**MONTGOMERY COUNTY HISTORIC PRESERVATION COMMISSION**  
**STAFF REPORT**

| <b>Address:</b>       | 5810 Cedar Parkway, Chevy Chase                                | <b>Meeting Date:</b>  | 9/6/2023      |
| <b>Permit Number:</b> | 1040631  | <b>Staff:</b>         | John Liebertz |

**PROPOSAL:** Window replacement and hardscape alterations.

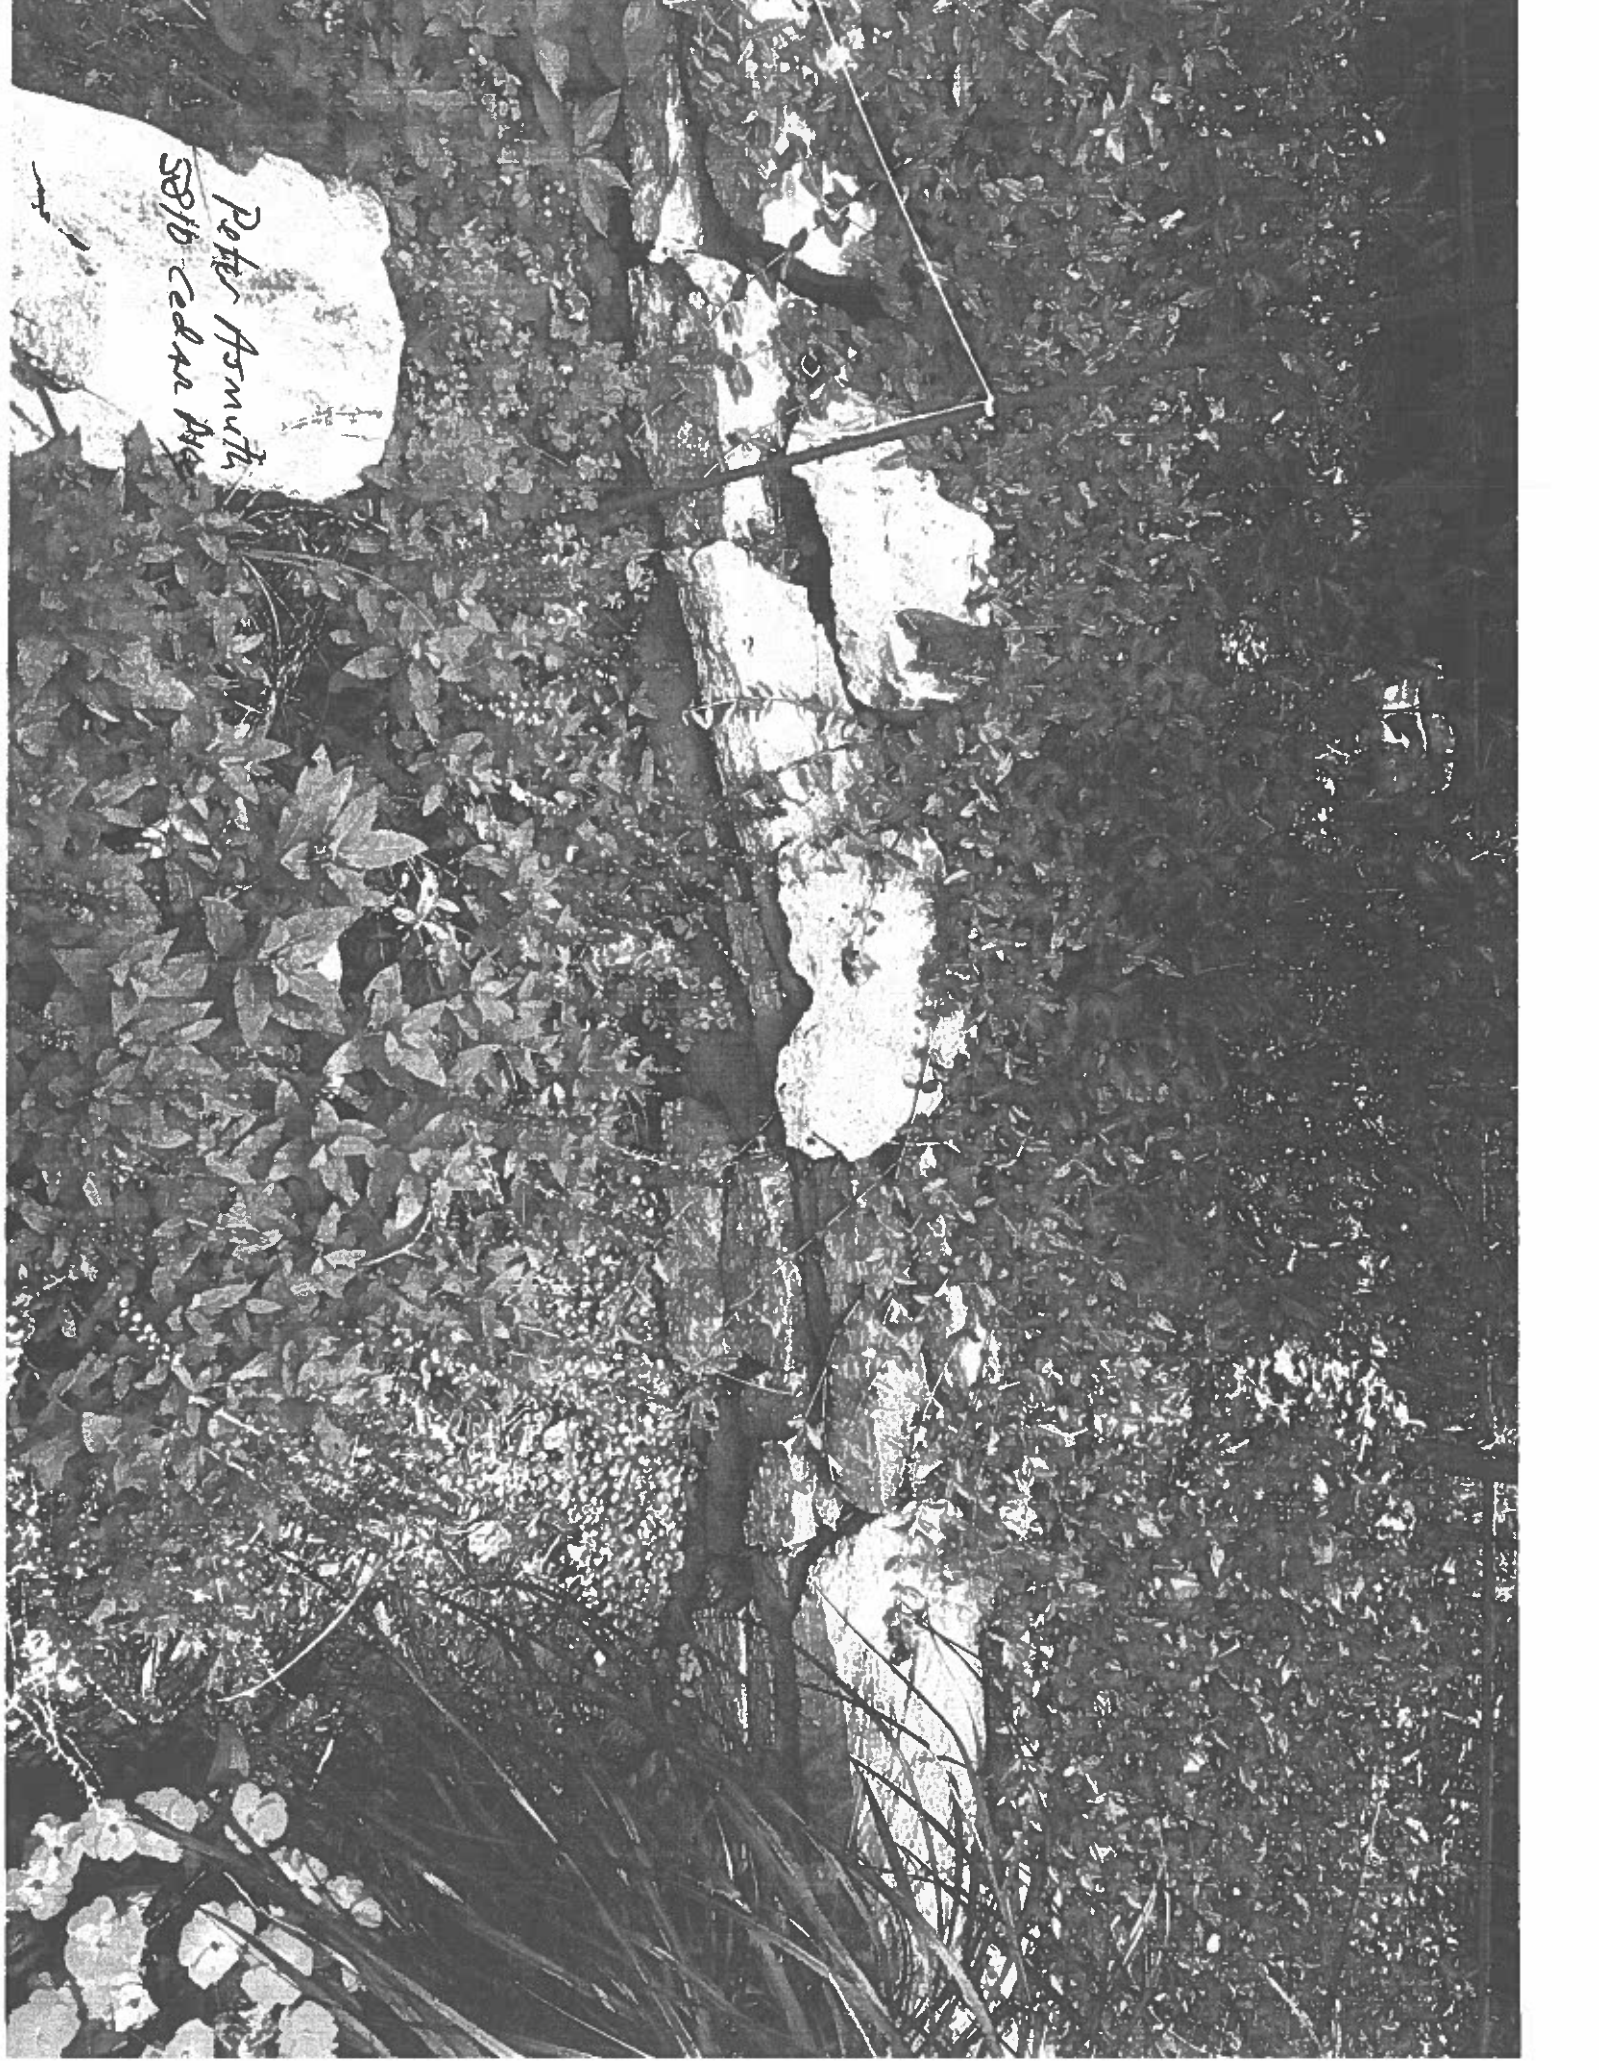
Staff finds that raising of the height of the existing stone retaining wall from 15” to 20” and installation of a matching 15’-long ell stone retaining wall in the rear yard to be consistent with the applicable guidelines and recommends approval (*Figure 4*). Staff reviewed the installation with “lenient scrutiny” per the guidelines. The HPC regularly approves the installation of stone retaining walls. The proposal would neither be visible from the public rights-of-way nor would it adversely affect the park-like setting of the historic district. Therefore, the proposal should be approved as a matter of course.

Proposed  
extending  
wall

Current  
garden  
wall
